INITIAL RECOMMENDATION OF THE NORTHEAST DESIGN REVIEW BOARD

Project Number: 3012601

Address: 3400 Stone Way

Date of Meeting: Monday, March 19, 2012

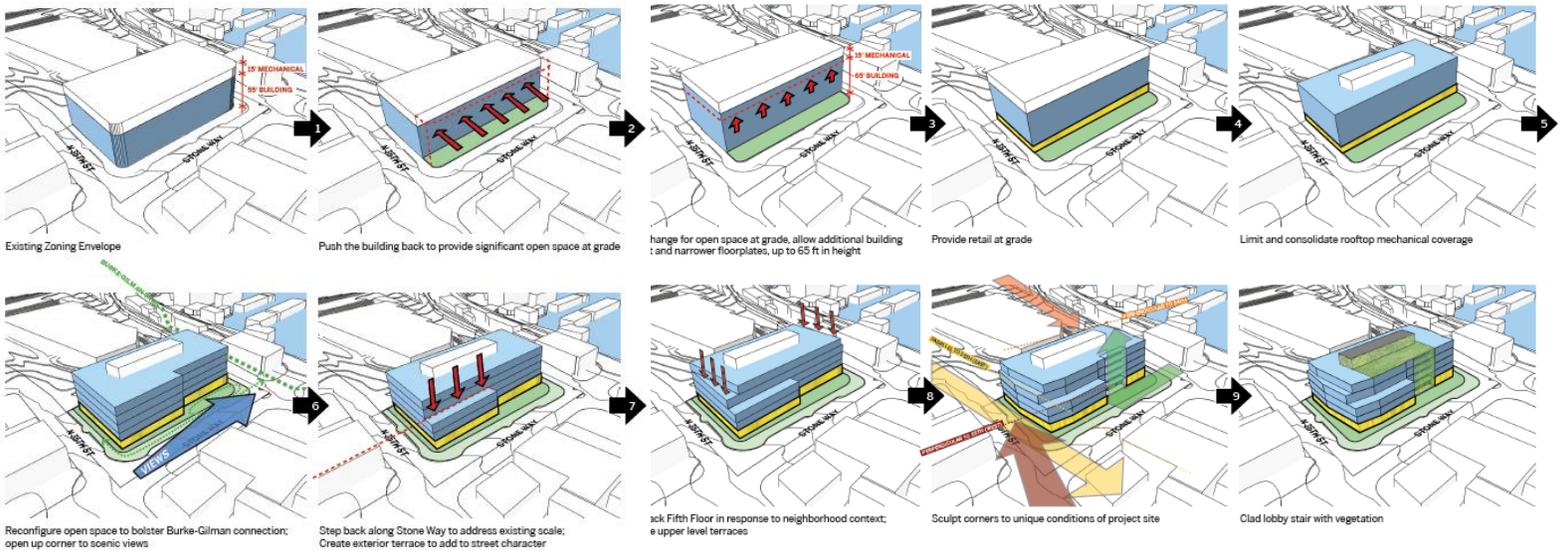
The first alternative (Concept 1) showed a code-compliant 45-foot tall building form situated directly at the property lines without setbacks provided (none are required in the IC zone) filling in the parallelogram shaped site. The applicant noted that the proposed design would have more difficulty in potentially meeting the imperatives of the Living Building Challenge due to the resultant floor to floor height that minimizes daylight penetration. This alternative also did not include a retail use at ground level; the entire building was office use.

The second and third options assumed the passage of a proposed code amendment to the Living Building Pilot Ordinance that would allow a height departure for up to 20 feet (for a total base building height of 65 feet) and the ability to not count the retail use towards the Floor Area Ratio calculation. Both of these options included four floors of office use above one floor of retail use.

The second alternative (Concept 2) "Offset Planes" included a rectangular building form where the floor plates would shift in and out slightly to capture views, respond to the context and provide a more dynamic appearance. All floor plates, including the ground level were rectangular in shape. The entry lobby was situated off of North 34th Street. The situating of the rectangular building form on the parallelogram shaped site resulted in triangular ground-level open space plaza areas at the southeast and northwest corners of the site.

The third and preferred alternative (Concept 3) "Stepped Façade" included massing that stepped back from Stone Way to create ground level open spaces at the corner where the principal intersection is located and across from where the Burke Gilman Trail becomes visible. The upper level floor plate extended beyond the ground level floor plate to create a more regular rectangle shape with a singular notch inward south of the stairwell feature. The mass was articulated by an outboard stair well that defines and grounds itself in the main entry
